ADDENDUM

Date Issued:	July 28, 2020
Project:	Intermountain Healthcare **IMC- Cath Lab #2 Remodel** 5121 South Cottonwood Street Murray, Utah 84107
Addendum Number:	1

Revised Sheet A101, A111, EQ101, EQ102, EQ104, & EQ105.

Demolition Floor and Ceiling Plan - Level 1

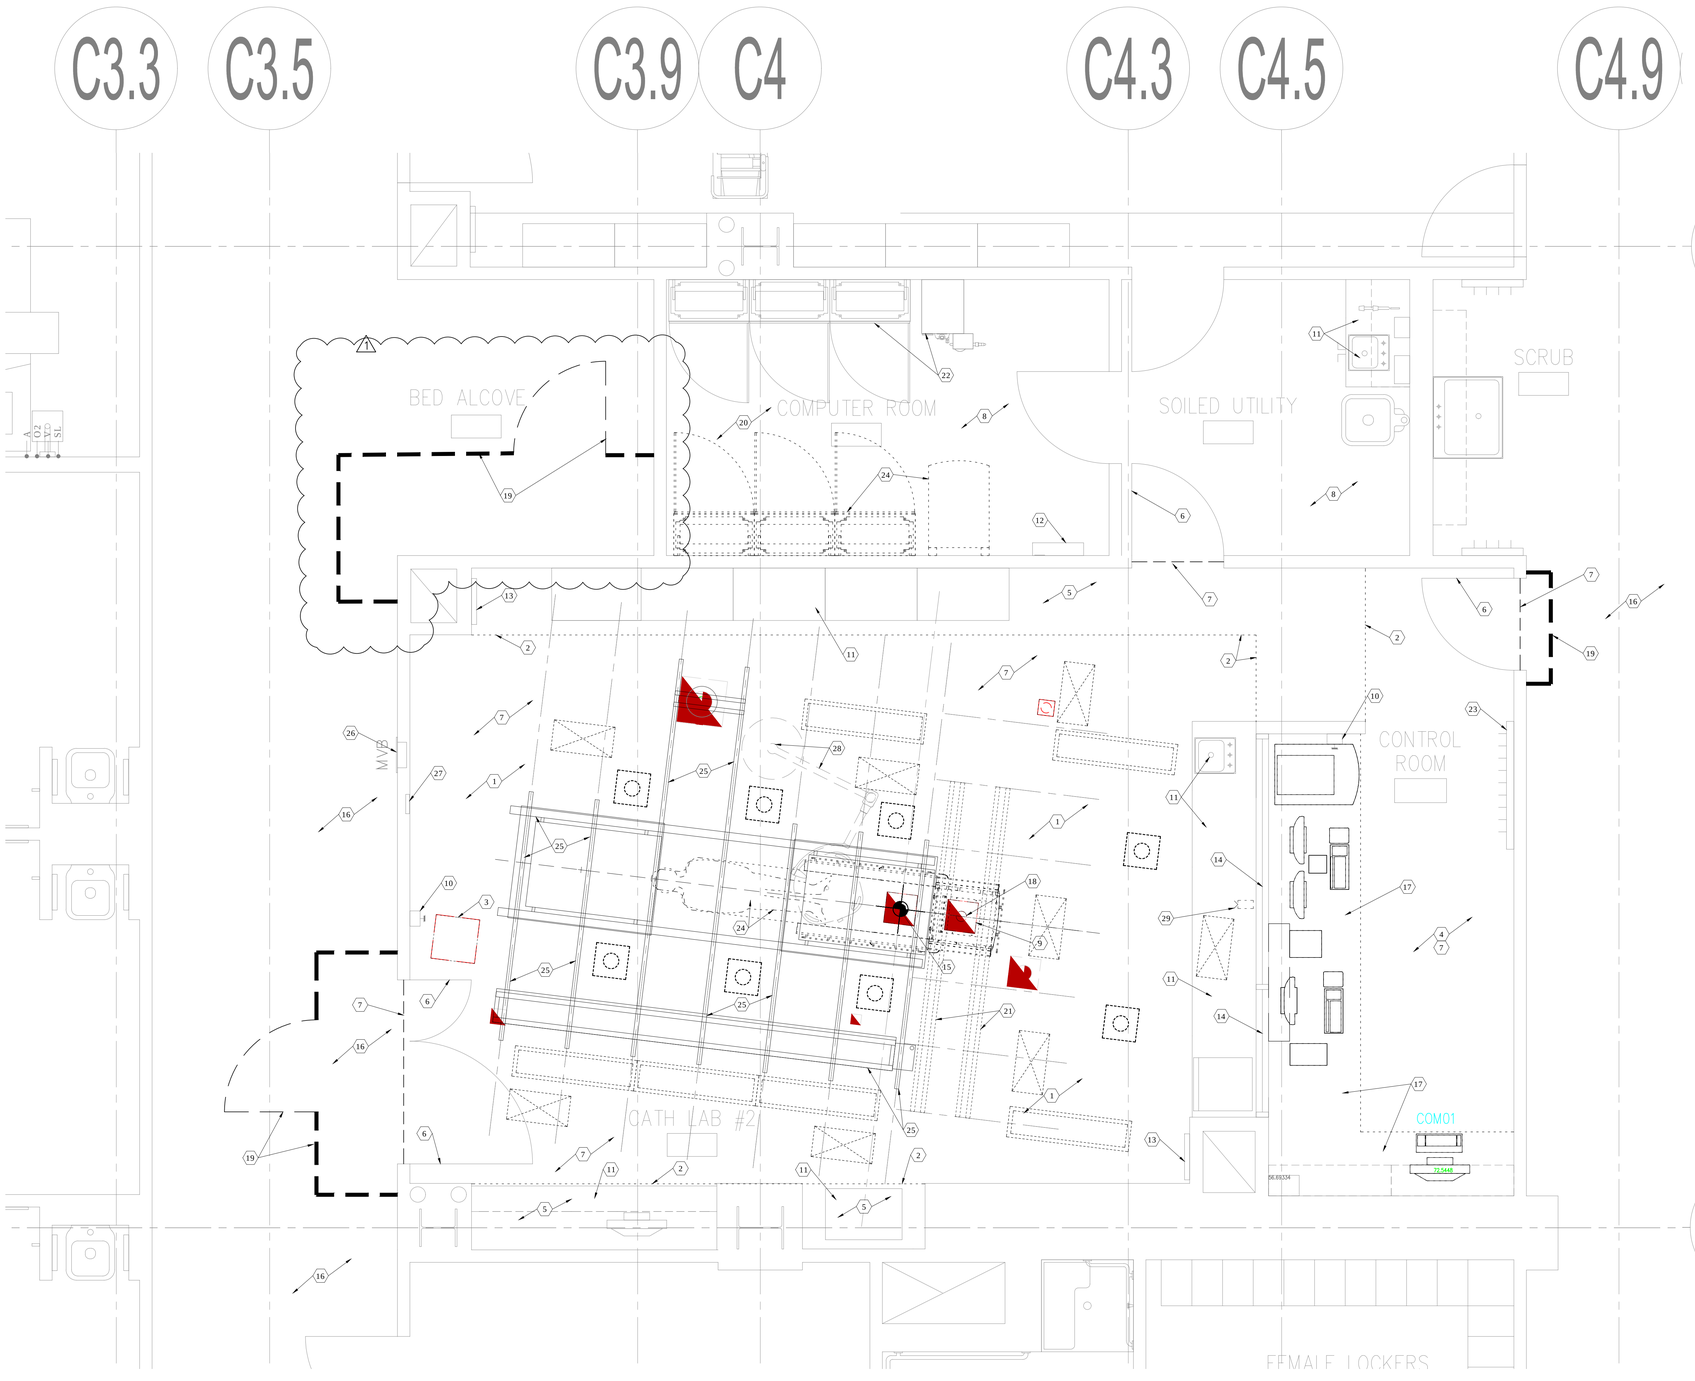
Sheet Number	Drawings
Architectural	
A101	Notes have been added to the demolition floor and ceiling plan. See attached revised sheet with revisions shown clouded.
A111	Data rack size has been updated in the new floor plan sheet. See attached revised sheet with revisions shown clouded. Coordinate and verify location of the data rack in the equipment room with the owner's vendor.
Equipment Drawings	
EQ101	See attached revised Siemens Equipment sheet with revisions shown clouded.
EQ102	See attached revised Siemens Equipment sheet with revisions shown clouded.
EQ104	See attached revised Siemens Equipment sheet with revisions shown clouded.
EQ105	See attached revised Siemens Equipment sheet with revisions shown clouded.
